## Vivian Silica Sand Project

**Expert Report on the Sio Silica Proposed  
Vivian Silica Sand Project**

The Rural Municipality of Springfield, Manitoba

## Executive Summary

Figure 31 – Pollution hazard map indicating areas of low, moderate and high aquifer vulnerability to impacts from surface activities.

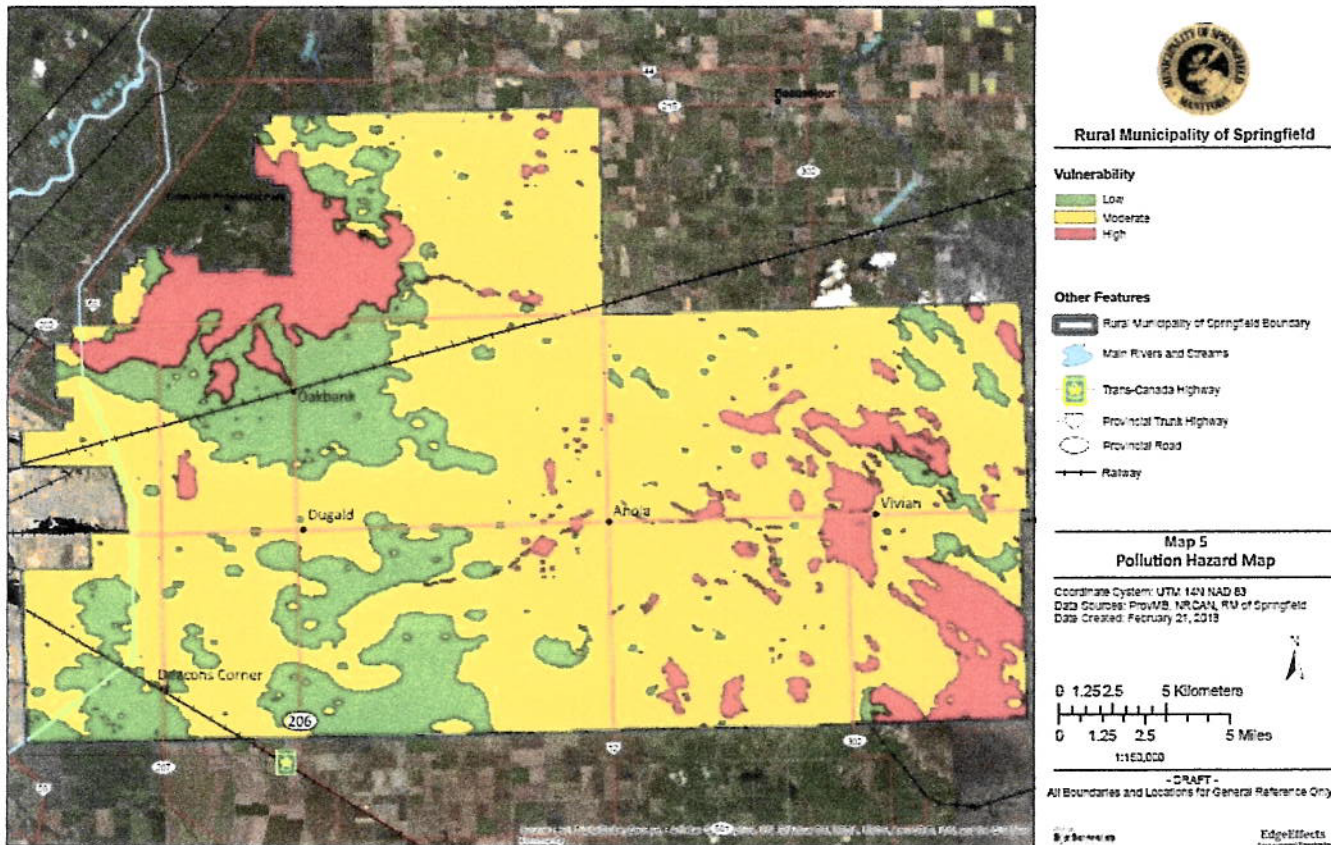
Fact: ground zero for extraction and processing at Vivian is in the zone above and below ground that is classified as " high aquifer vulnerability"(FD 1&2 attached).

Figure 1. Concept for the proposed well layout during operations

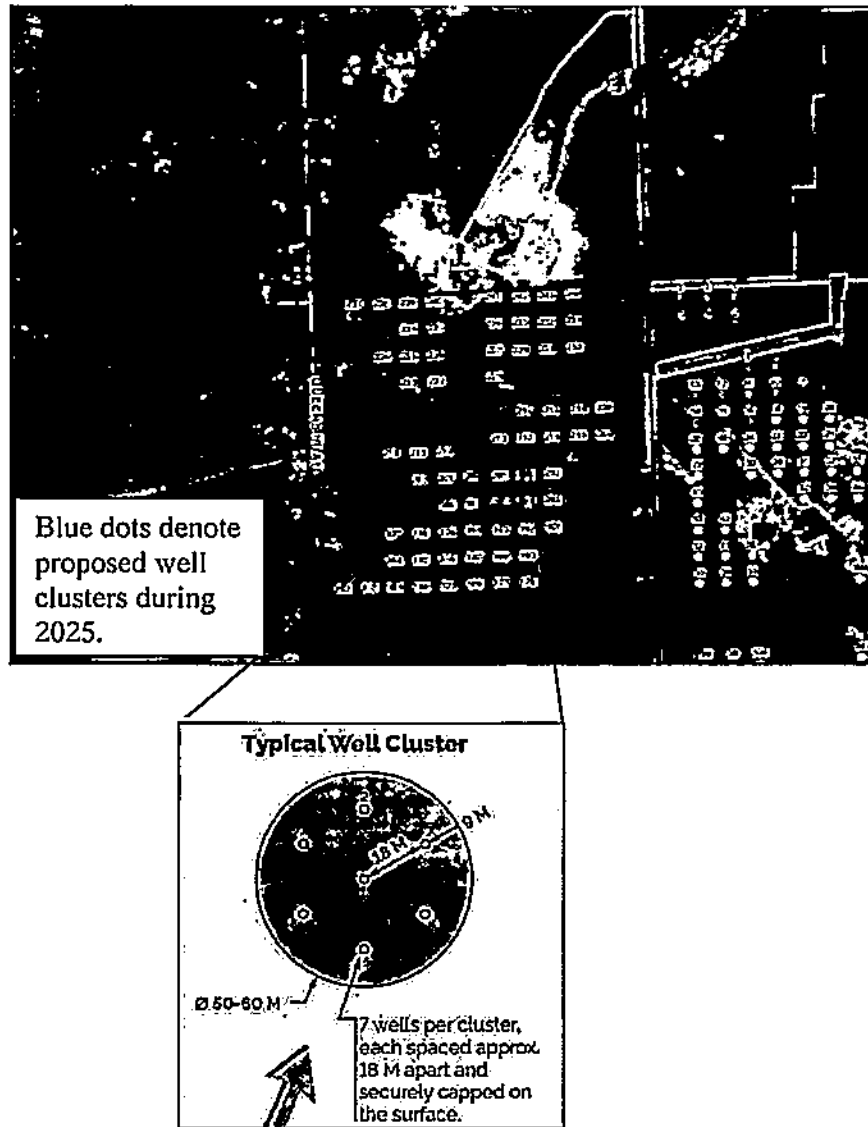
2. A mining plan for the first five years of operations is presented in Figure 6-5 of the Hydrogeology and Geochemistry Assessment Report Referring to the excerpt from this figure shown here in Figure 1, each blue dot represents a cluster of 7 wells that will be drilled, operated and abandoned during 2025. The corresponding schedule of pumping is shown in Figure 6-7 of the report. During each year, pumping will shift from one cluster to the next (for example, from Cluster 213 to Cluster 214).

In response to RMSF-IR-004, the proponent clarified the pumping rates assumed in the impact assessment. Each well in the cluster is planned to be operated for approximately 4 days at a variable rate ranging from 262 m<sup>3</sup>/day to 654 m<sup>3</sup>/day (48 to 120 USgpm). If all 7 wells in a cluster were operating continuously this would correspond to 1,834 m<sup>3</sup>/day to 4,578 m<sup>3</sup>/day (336 to 840 USgpm). It is indicated in the response that the overall average combined production rate is expected to be 2,943 m<sup>3</sup>/day. For the predictive simulations, during each year's simulated operating period the cumulative pumping is assumed to be 2,998 m<sup>3</sup>/day (540 USgpm), slightly higher than the expected average. The cumulative pumping of 2,998 m<sup>3</sup>/day corresponds to 550 USgpm, which is the rate assumed in the impact assessment, as indicated in Figure 6-7 of the Hydrogeology and Geochemistry Assessment Report

3. The responses to RMSF-IR-005 clarify that there may be extraction pumping at the same time as treated pumped water is re-injected at wells in the same cluster. The net groundwater withdrawals may therefore vary from 100% to some smaller fraction of the 550 USgpm, depending on the rate at which water is re-injected.
4. It is indicated on Page 22 of the Hydrogeology and Geochemistry Assessment Report that extraction wells within each cluster will be located "approximately 22 m apart". This is not consistent with the conceptual layout shown in Figure 2-B (see Figure 1 below), which suggests that the wells will be spaced 18 m apart. In response to RMSF-IR-006, the proponent has indicated that the text in Section 2.3 and Figure 2-B of the Hydrogeology and Geochemistry Assessment Report should have reflected a well spacing of 18 m.

Figure 3. Distance-drawdown analysis for Bru 95-7 pumping test  
Adapted from AECOM (2021; Appendix E.2)

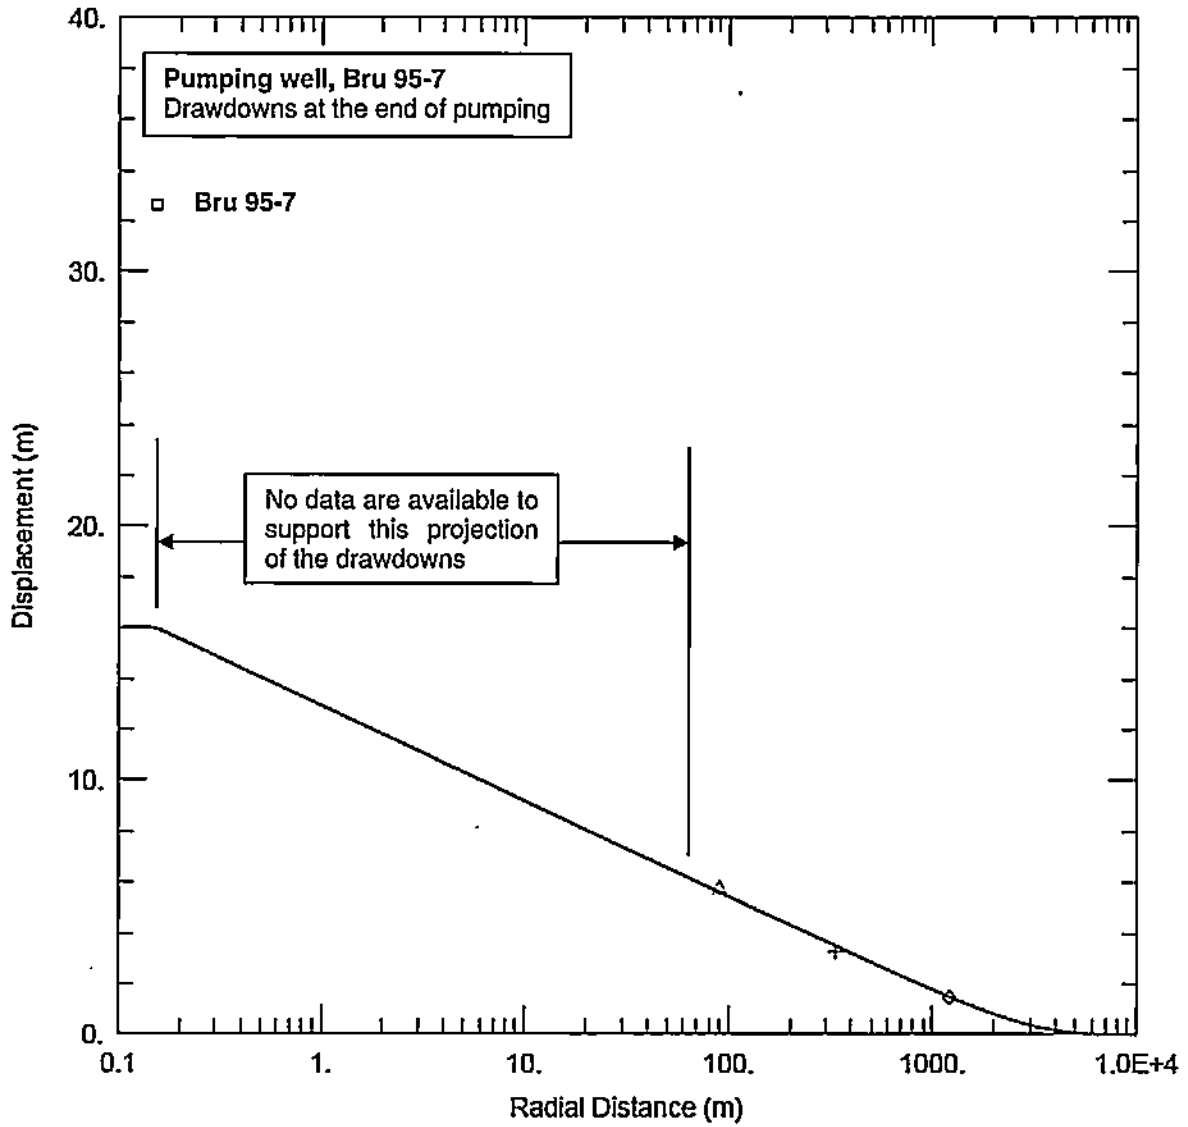
9. The data from step drawdown tests can frequently be used to identify additional well losses so that the drawdowns from the pumping well can be treated as if the well was another observation well. The data from the step test may have provided valuable insights explaining the relatively low efficiency of the pumping well (the observed drawdown at the end of pumping of about 32.5 m is about double that inferred from the distance-drawdown analysis).

It is suggested on Page 31 of the Hydrogeology and Geochemistry Assessment Report that the "excess drawdown" in the pumping well was due primarily to residual drilling mud in the sand pack and surrounding formation. This does not appear to be consistent with the text on Page 26 of the report, which indicates that an extensive development effort was undertaken prior to conducting the constant-rate pumping test.

Figure 4 Inference of additional well losses in Bru 95-7  
Adapted from AECOM (2021; Appendix E.2)

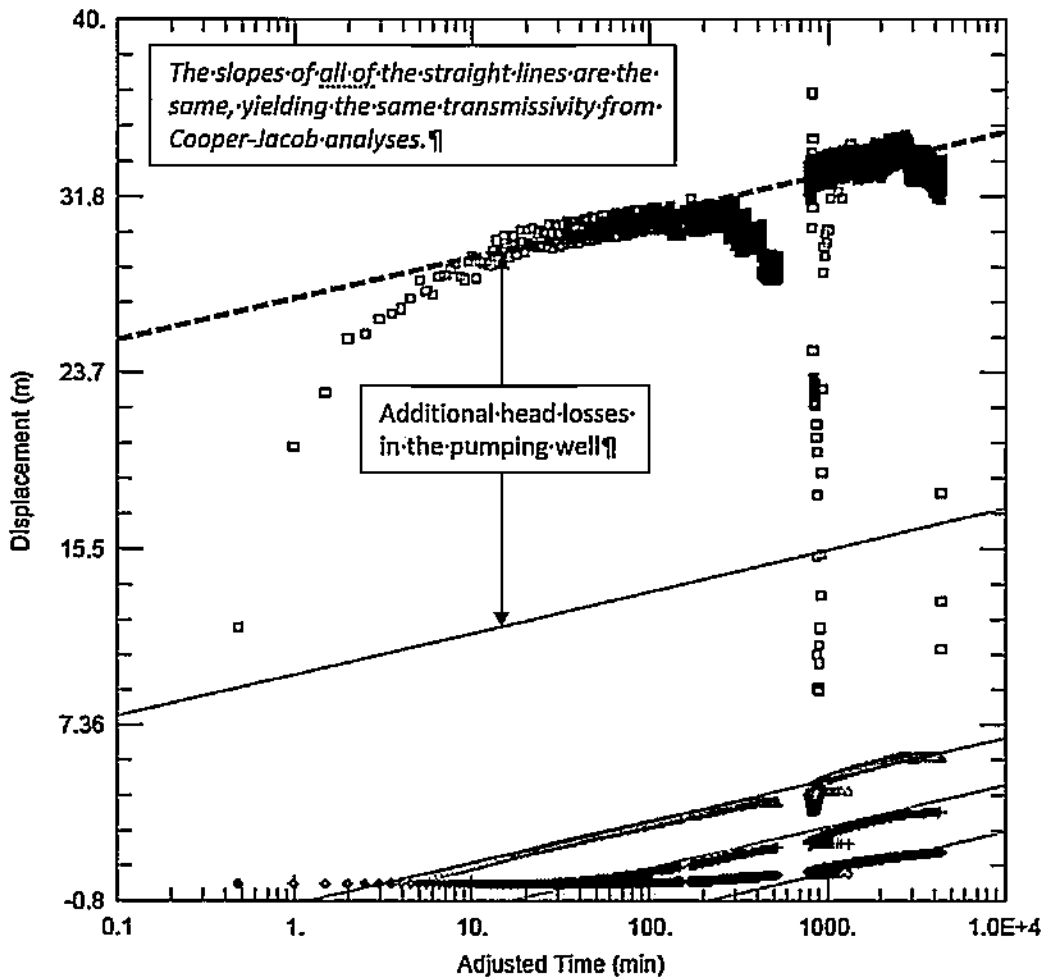
10. The analytical models used to match the observations from the Bru 95-7 pumping test are the based on the Theis (1935) model of an ideal confined aquifer. Among the most important assumptions of the Theis solution is that the aquifer is homogeneous. Some of the results of the analyses listed on Table 3-C of the Hydrogeology and Geochemistry Assessment Report are consistent with this assumption, while others are not. The transmissivities estimated from matching the observation well drawdowns with the Theis solution and the Cooper and Jacob (1946) straight-line analysis are consistent, as they should be when applied in a consistent manner. In contrast, the matching of the pumping well drawdowns with the Theis solution yields a transmissivity that is about half of the value estimated for the observation wells. The transmissivity estimated by matching the observed pumping well drawdowns with the Theis (1935) solution is not reliable here, as the analysis is affected by additional well losses. As shown in Figure 4 here, the Cooper-Jacob analysis effectively filters the additional well losses and the transmissivity estimated for the pumping well is consistent with the observation wells.

Figure 5. Recovery analysis for the Bru 95-7 pumping test  
Adapted from AECOM (2021; Appendix E.2)

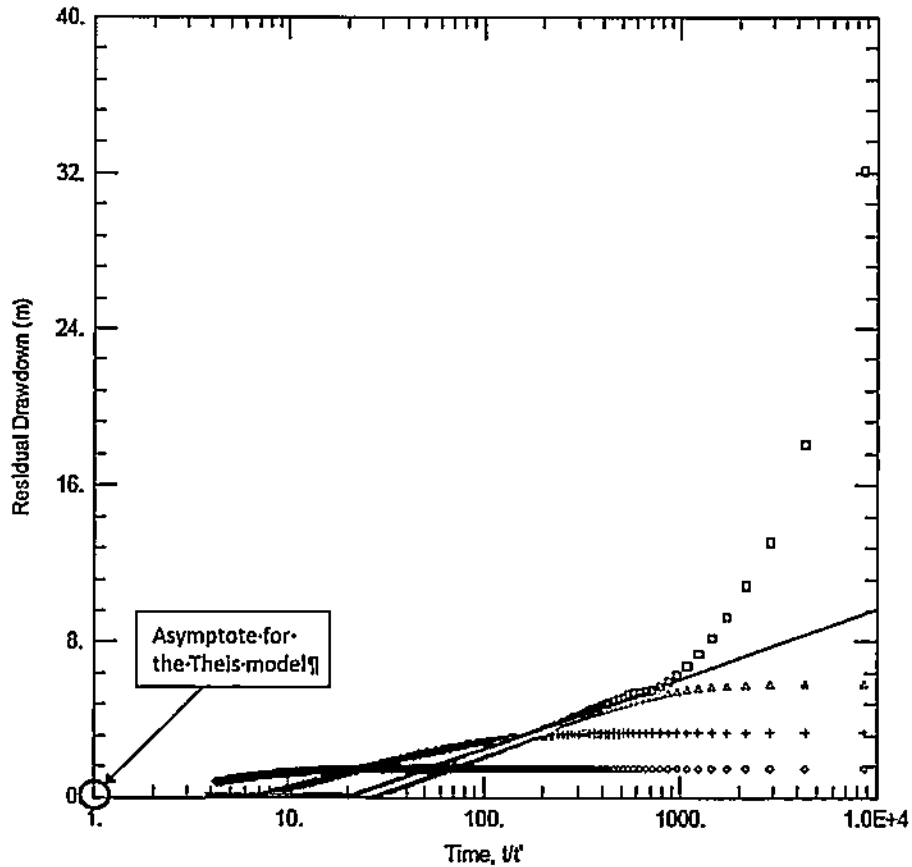
11. The responses observed following the end of pumping are complex. In an ideal confined aquifer, the recovery data for the pumping well and observation wells should eventually approximate a single straight line that approaches the asymptotic value of zero residual drawdown as  $t/t'$  approaches a value of 1.0 (indicated by the red circle in Figure 5). The data satisfy neither of these conditions. The fact that the recovery records approach values of zero drawdown for values of  $t/t'$  of about 9, 20 and 25 rather than 1.0 suggests that the drawdown cone at the end of pumping is replenished by a source of water in addition to confined storage.

Figure 7. Simplified Thornthwaite-Mather analysis to estimate the average annual surplus

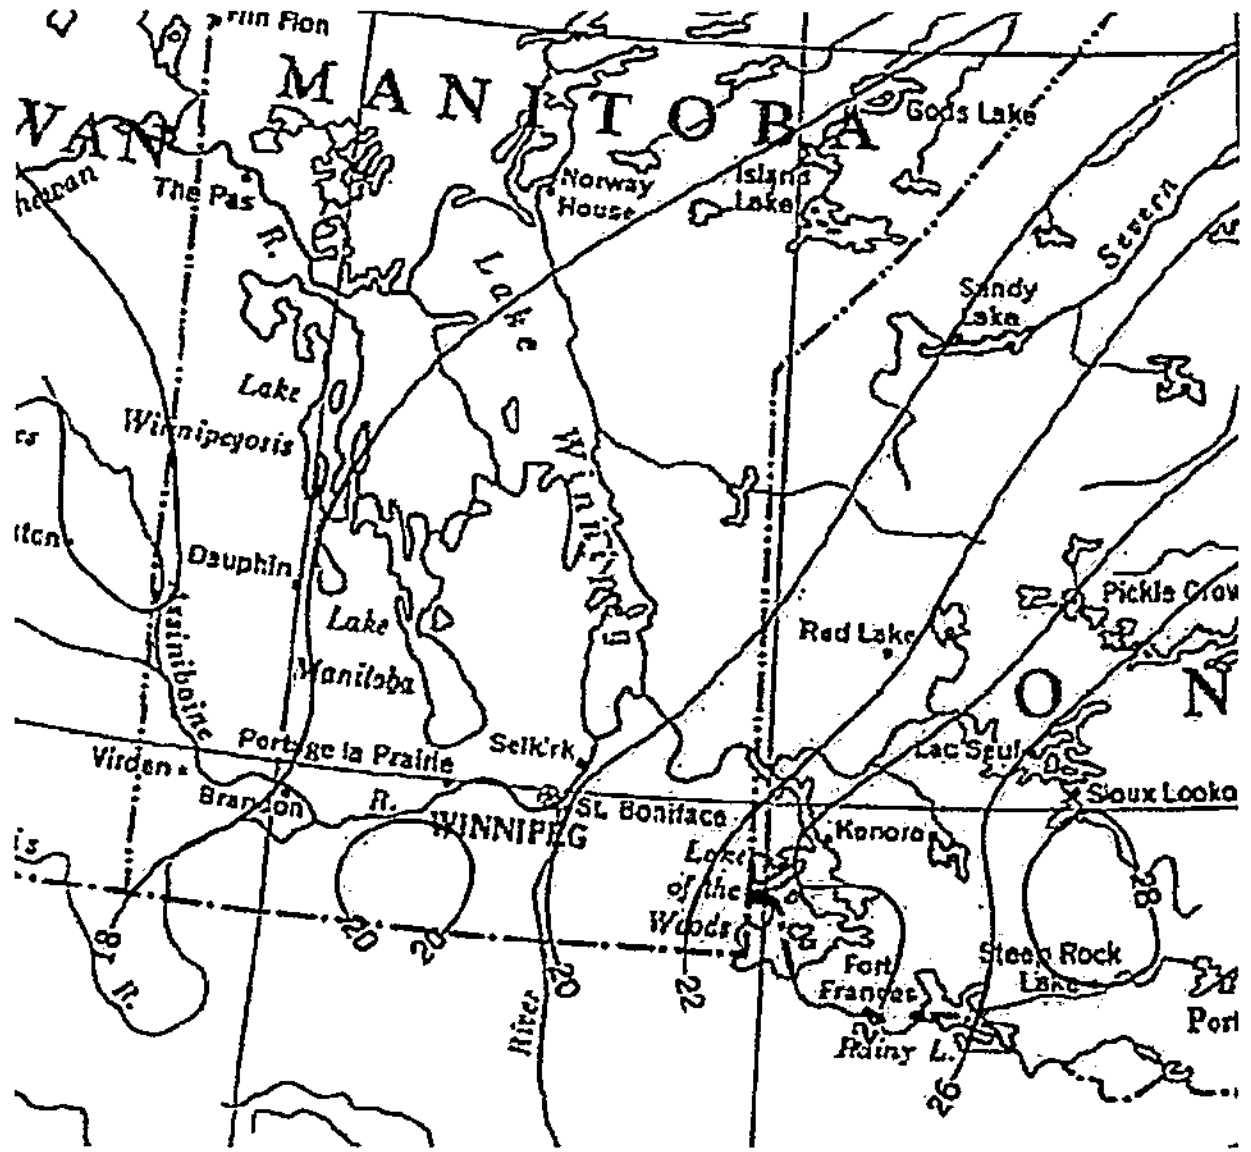
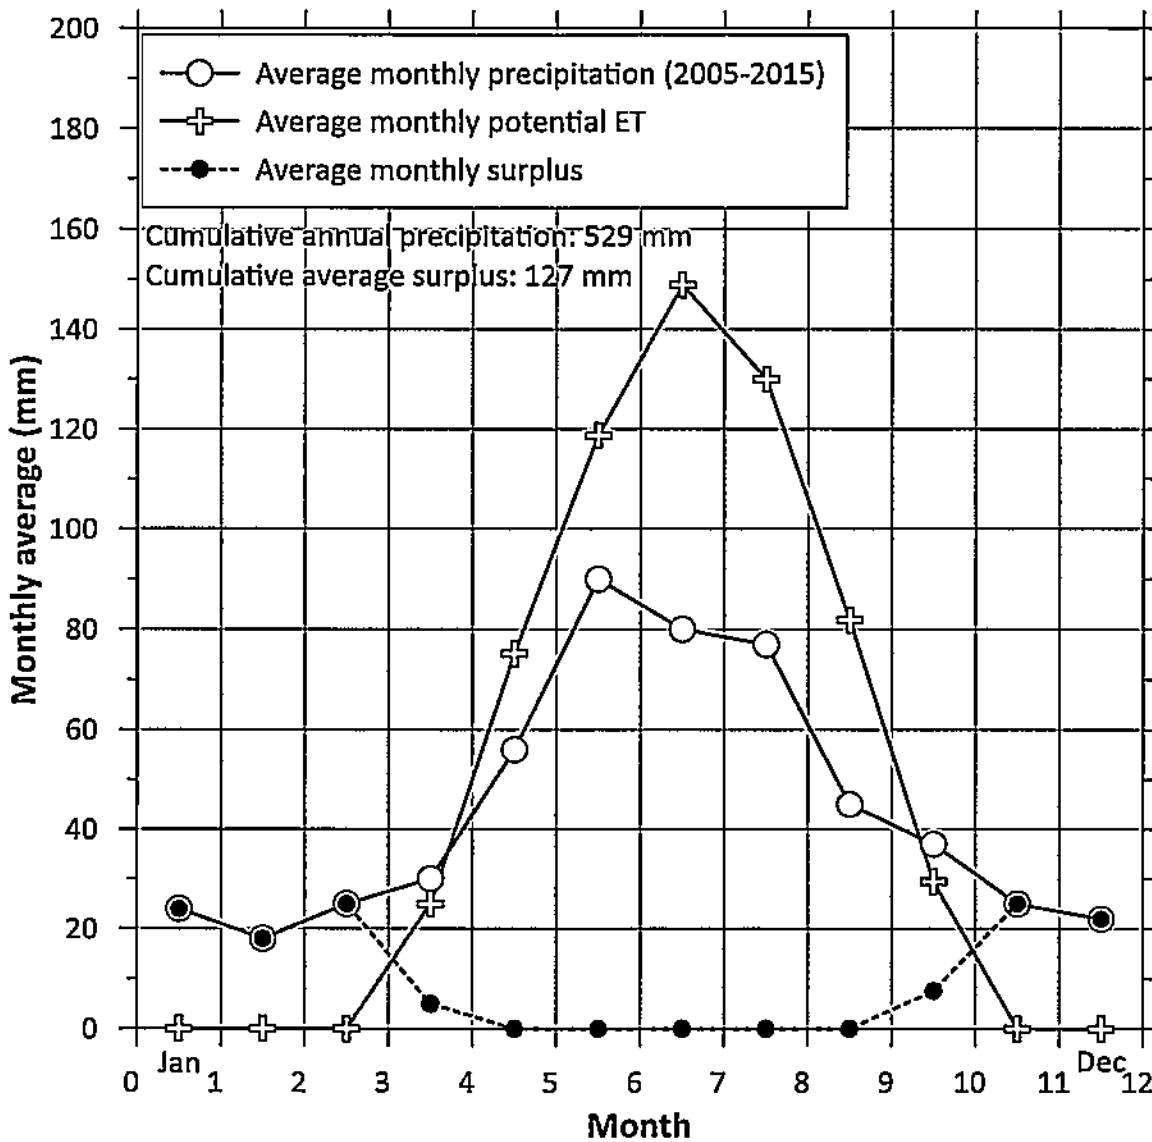
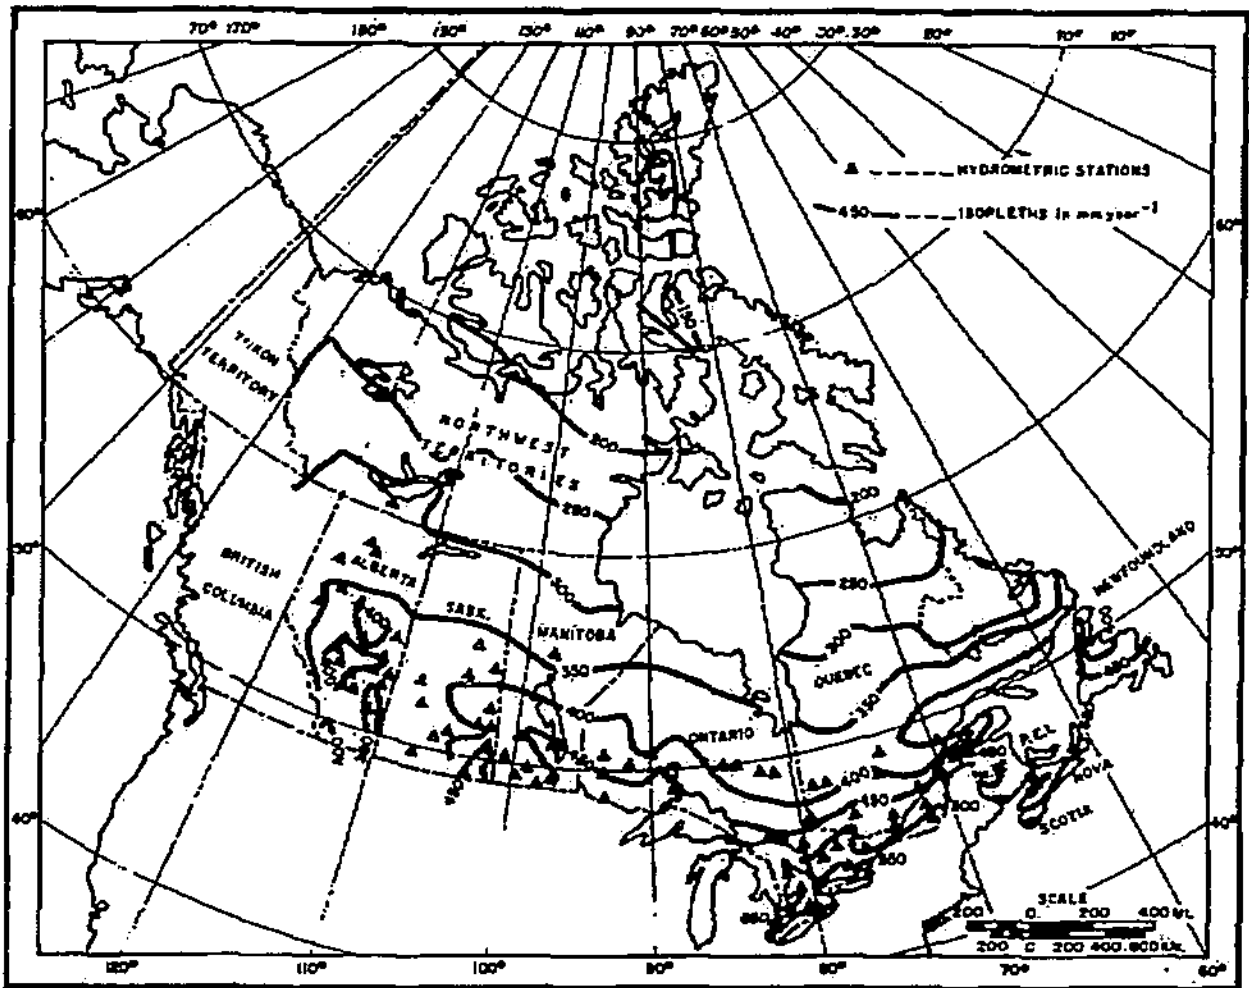
17. In my opinion, it is possible that the recharge over the model area is overestimated. It is indicated on Page 73 of the Hydrogeology and Geochemistry Assessment Report that the recharge is related to the mean annual precipitation at the Ostenfeld climate station for 1981-2020, 639 mm. Depending on the source, it appears that the average annual precipitation near Winnipeg is substantially less, between about 450 mm and 520 mm (see for example, <https://weather-and-climate.com/average-monthly-precipitation-Rainfall-inches.winnipeg.Canada> and <https://www.weather-atlas.com/en/canada/winnipeg-climate#snowfall>). Referring to the excerpt from the Atlas of Canada reproduced here in Figure 6, the average annual precipitation over the study area is about 21 inches (530 mm).

A simplified analysis of the precipitation surplus (Precipitation – Evapotranspiration), which represents the maximum amount of water that is available to recharge the water table, has been developed with the Thornthwaite-Mather analysis. According to the results of my calculations shown in Figure 7, the average annual surplus is about 130 mm. The implied annual evapotranspiration from the Thornthwaite-Mather analysis is 400 mm, which is roughly consistent with the average annual value of 450 mm mapped in Morton (1975) [see Figure 8].

The recharge rates applied for the Birds Hill and Sandilands areas of the groundwater model are substantially larger than 130 mm (250 mm/yr and 189 mm/yr, respectively). Specification of too high recharge rates will have the effect of attenuating the simulated effects of the proposed development. In my opinion, it is appropriate practice to obtain water budgets from the Engineering Climate Services of Environment Canada for several climate stations around the study area ([ec.scg-ecs.ec@canada.ca](mailto:ec.scg-ecs.ec@canada.ca)).
